Date: March 2, 2018
To: Kidde Engineered Systems Integrators – Limited Circulation
From: Product Management
Subject: Safety Bulletin: HPCO₂ Hose-Reel Horn-Valve Assembly

IMPORTANT SAFETY NOTICE – ACTION REQUIRED

Figure 2: Horn-Valve Underside View (Horn removed from outlet for clarity only)

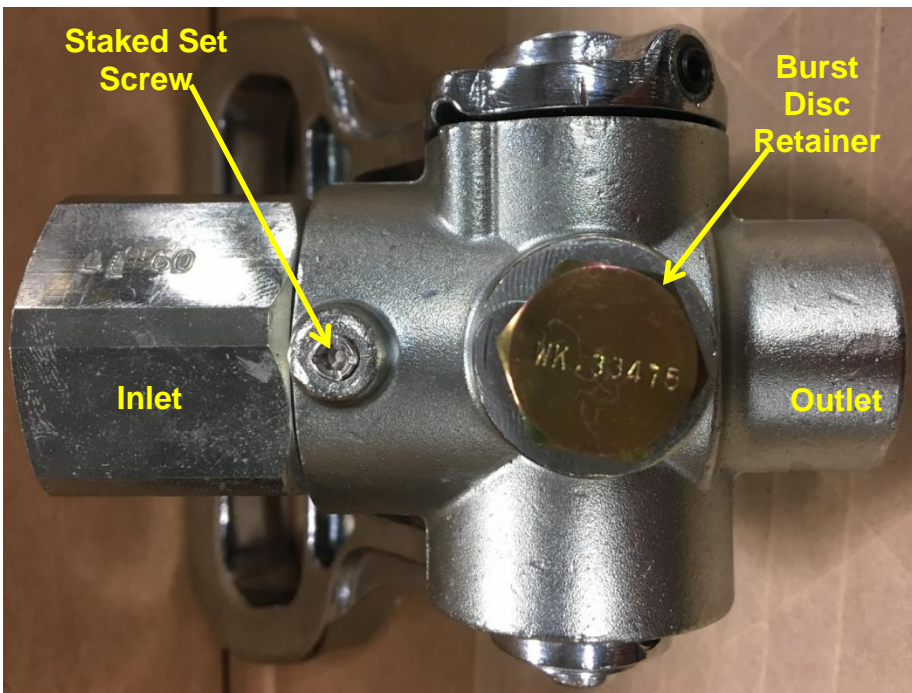
During a service call on a commercial vessel, a hose-reel horn-valve assembly failed at the junction of the valve body and adapter resulting in the valve separating from the hose. Investigation is underway. ***To mitigate risk of death, physical harm and injury to all personnel involved with servicing, maintaining and operating HPCO₂ systems, we highly recommend completing the actions outlined in the Recommended Field Action section of this Safety Bulletin at your next service opportunity.***

1. Please immediately share this bulletin with all of your land and marine end-users, customers, ship-yards, vessel owners and operators reminding them of our strong recommendation to ONLY USE AUTHORIZED AND TRAINED KIDDE DISTRIBUTORS TO SERVICE KIDDE HPCO₂ SYSTEMS.
2. At the next service opportunity, perform the following steps:
 - a. Disarm the system in accordance with the applicable manual
 - b. Remove the Horn-Valve assembly from the restraint
 - c. Visually inspect the Horn-Valve assembly as a whole for signs of damage or tamper (see Figure 2)

Figure 3: Horn-Valve View Showing Burst Disc Vent Holes

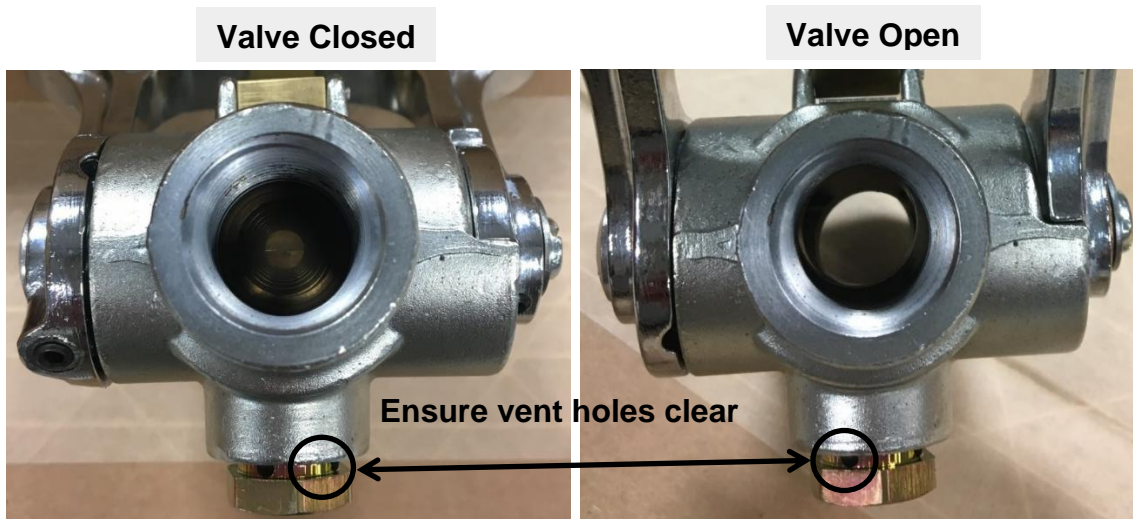
- d. Inspect the burst disc retainer and ensure that the vents are clear (see Figure 3)
